New Reactors Division

**Step 4 Assessment of Management of Radioactive Wastes for the UK Advanced Boiling
Water Reactor**

Assessment Report: ONR-NR-AR-17-025
December 2017 Revision 0

Figure 2: Flow Diagram for the Low Chemical Impurities Waste (LCW) Treatment System

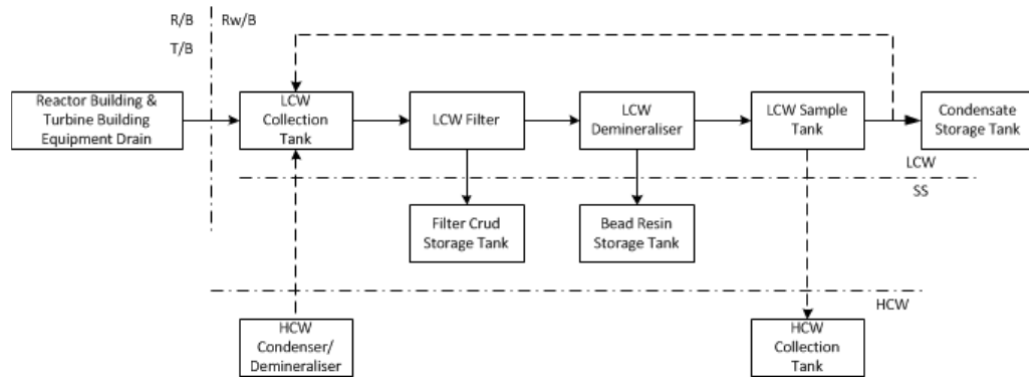
206. The Process Description stated a maximum flow rate and a normal flow rate, but also an annual daily average rate of 27.8m³/day and this raised questions regarding the operating intent of the system. Whilst ONR's assumption was that the tanks are intended to operate on some form of batch cycle basis, this had to be inferred as it was not made explicit within the safety case, which therefore failed to adequately describe the nature of the feed to the LCW.

214. The Basis of Safety Case (Ref.21) stated that in 'rare events', LCW liquor will be sent to the HCW system for processing. ONR would therefore expect the safety case should provide a clear definition of a 'rare event', together with clear objective criteria that define when the effluent transfer operation from LCW to HCW will occur.

231. Therefore ONR would expect the safety case should provide an understanding of how liquor transfer between the LCW and HCW will occur and be controlled, to ensure the ongoing operability of both systems whilst this treatment method is implemented. However Hitachi-GE's generic case did not provide any explicit consideration of these aspects, which I considered to be a shortfall in the underpinning of the concept design in relation to SAPS RW.1, RW.4 EPE.1, EPE.2 and EPE.5.

Figure 9:
Reactor Off-Gas System Sections for the Purpose of Hydrogen Management

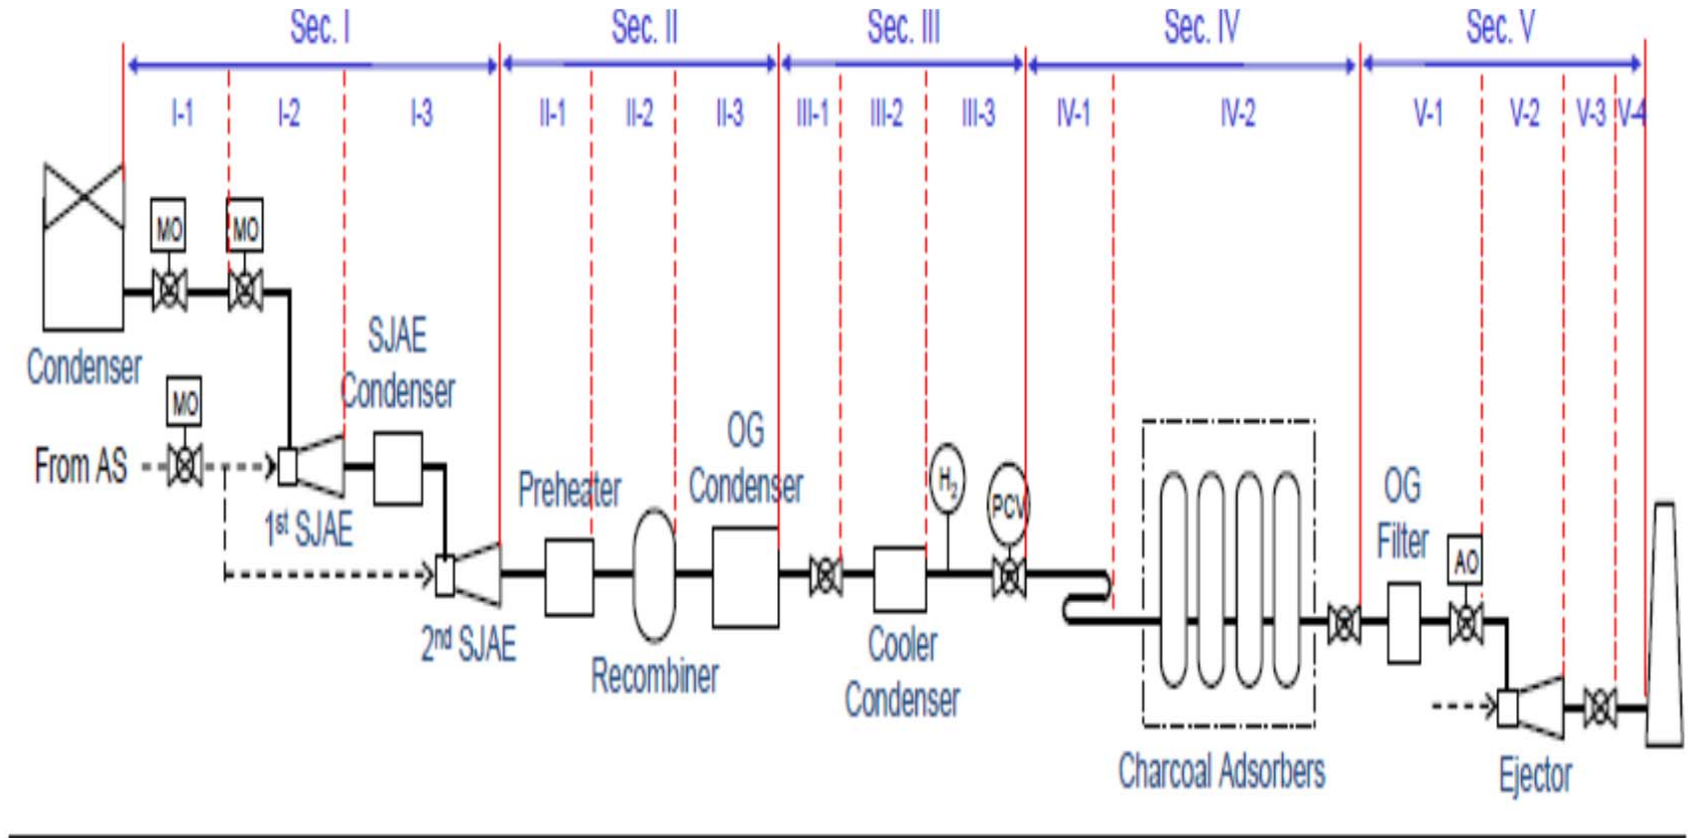
295. However, I noted that Hitachi-GE had not apparently considered any form of catalytic recombiner in either the pipe from the first SJAE to the SJAE condenser, or from the SJAE condenser to the second SJAE (Section 1-3 in Figure 9). There appeared to be no consideration of the potential to introduce any catalyst at these stages. Whilst I would not expect a full-sized recombiner to be placed in Section 2, it may be possible to achieve a worthwhile degree of hazard reduction by inserting a relatively small amount of catalyst into the pipework that will not significantly impact the system's operations.
